Department of Energy

Subject: U.S. Department of Energy Office of Legacy Management Response to the U.S. Nuclear Regulatory Commission Staff Review of the DOE Report *Annual Performance Report April 2019 through March 2020 for the Shiprock, New Mexico, Disposal Site* Dated August 2021 (WM-00058)

Attachment 1

*Figure 1. Uranium Concentrations in Floodplain Wells 0611, 0612, 0622, and 0855: 2006–2021
Shiprock, New Mexico, Disposal Site*

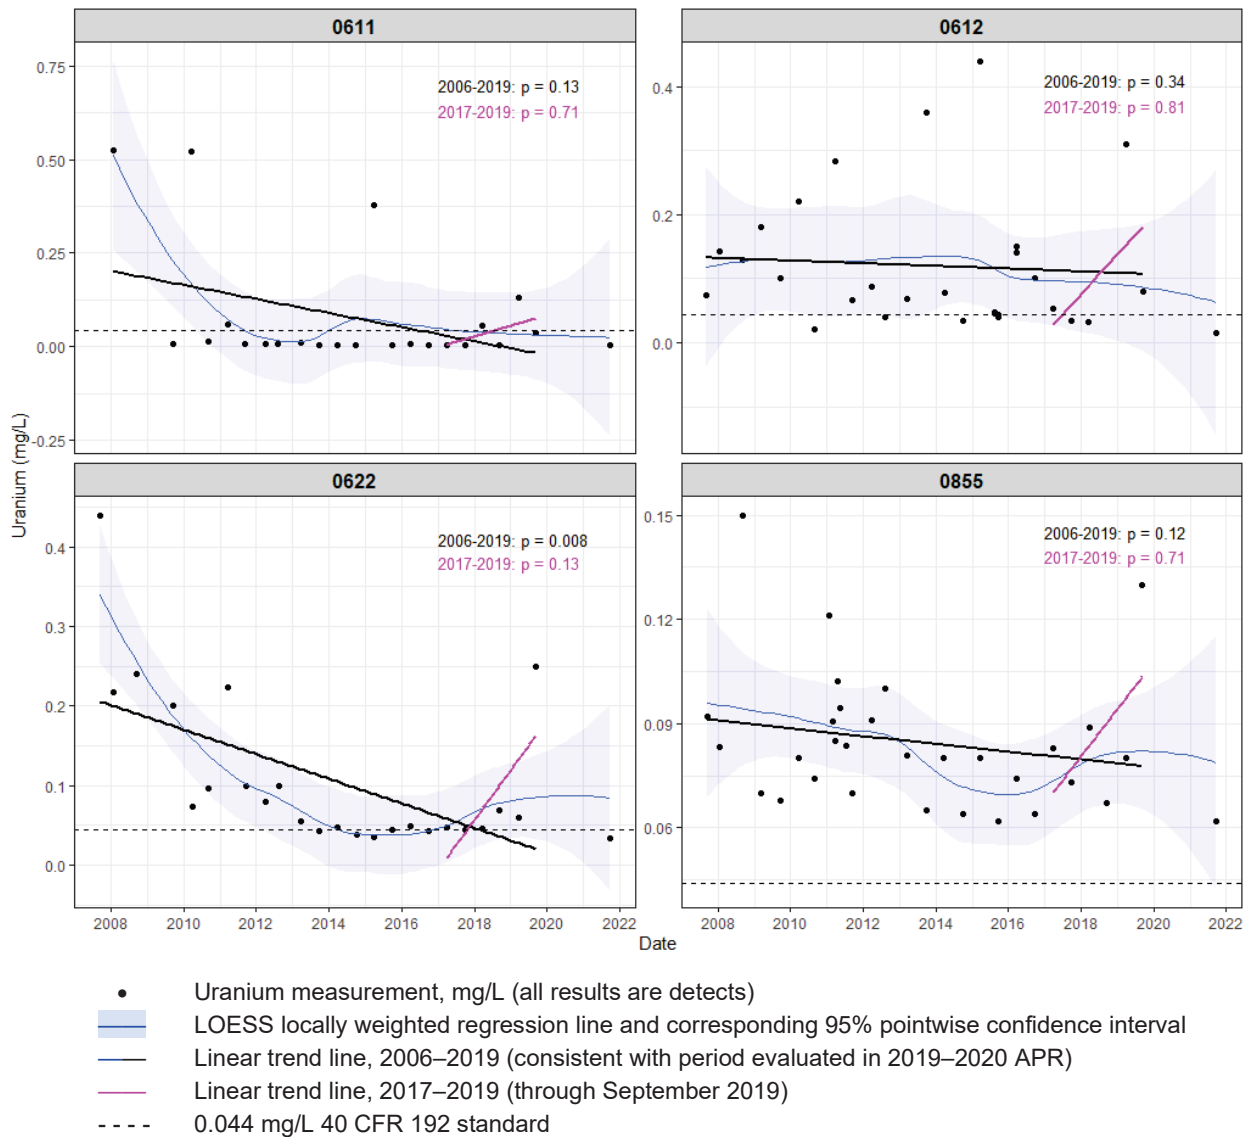
New to this performance report are the results of the Mann-Kendall trend analysis results for floodplain wells presented in Appendix B. NRC staff finds this analysis a useful addition to the performance report. However, it is not clear why some of the wells listed did not show an increasing uranium concentration trend. For example, wells 0611, 0612, 0622, and 0855 show an upward trend since the suspension of pumping in 2017 as can be seen in the uranium time-concentration trends in Figure 13. None of the four wells are labeled as increasing after the Mann-Kendall trend test was completed (see Table B-3) even though Section 3.3.1 states "Since the last reporting period, uranium levels increased markedly in two wells: central floodplain well 0622 and western floodplain well 0855." If the reason for this lies in the fact that the analysis was performed for lengthier time period, i.e., 2006 – 2019, than the time period at Shiprock with very little pumping, i.e., 2017 – 2021, then NRC staff would find the results of a Mann-Kendall trend analysis very useful for the shorter timeframe. NRC staff is aware that the data set for the 2017–2021 timeframe is much smaller, and that DOE may decide that it is too small for the Mann-Kendall trend analysis to be performed.

The reason the Mann-Kendall tests did not yield an increasing concentration trend for the floodplain wells in question (0611, 0612, 0622, and 0855) is because of the longer time frame evaluated in the 2019–2020 annual performance report (APR). The period evaluated was 2006–2019, in which 2006 marked the beginning of the expanded remediation system on the floodplain (the trenches were installed in spring 2006). LM acknowledges the apparent upticks in uranium concentrations in these wells, most evident for wells 0622 and 0855 as noted in the APR.

To address NRC's comment, LM ran the Mann-Kendall trend test for the shorter period following pumping reduction (2017–2019). Figure 1 (in Attachment 1) plots uranium concentrations for the four wells in question along with linear regression lines corresponding to both the 2006–2019 and 2017–2019 time frames. Despite the positive slopes shown for the linear trend lines for all four wells for the 2017–2019 period, none of the Mann-Kendall tests identified a statistically significant increasing trend (p -values ≤ 0.13 ; Figure 1). This is most likely because of the small sample sizes ($n=6$ measurements). Results from the recent September 2021 sampling effort are also plotted in Figure 1, mainly to demonstrate that the elevated concentrations measured in September 2019 were not sustained.

Plots are overlain with two-sided p-values yielded from Mann-Kendall trend tests for the periods shown. Despite the positive slope shown for the linear trend lines for 2017-2019 period, none of these trends are significant, likely due in part to the corresponding small sample sizes (n=6 measurements). Results for the recent September 2021 are also plotted (but not included in the trend analyses), mainly to demonstrate that the elevated concentrations measured in September 2019 were not sustained.
